ADA Curb Ramp New Construction Inspection Form (Parallel)

NW Timeric

23885.56

NW Lenox

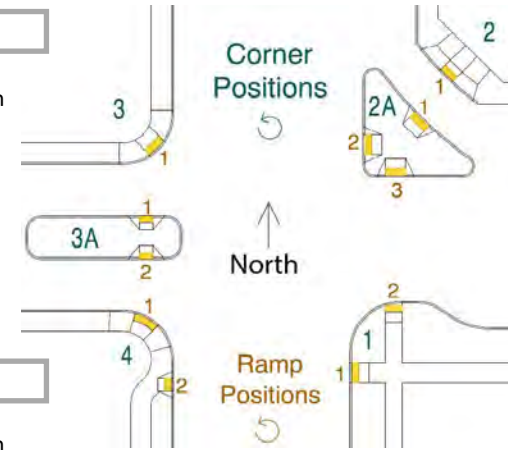
Y ☐ N ☒

$\leq 1/4"$ ☐ $> 1/4"$ ☒

4.1 $\leq 2.0\%$ ☐ $> 2.0\%$ ☒

10 $\leq 2.0\%$ ☐ $> 2.0\%$ ☒

NO DWS Fail RR and Turn Space
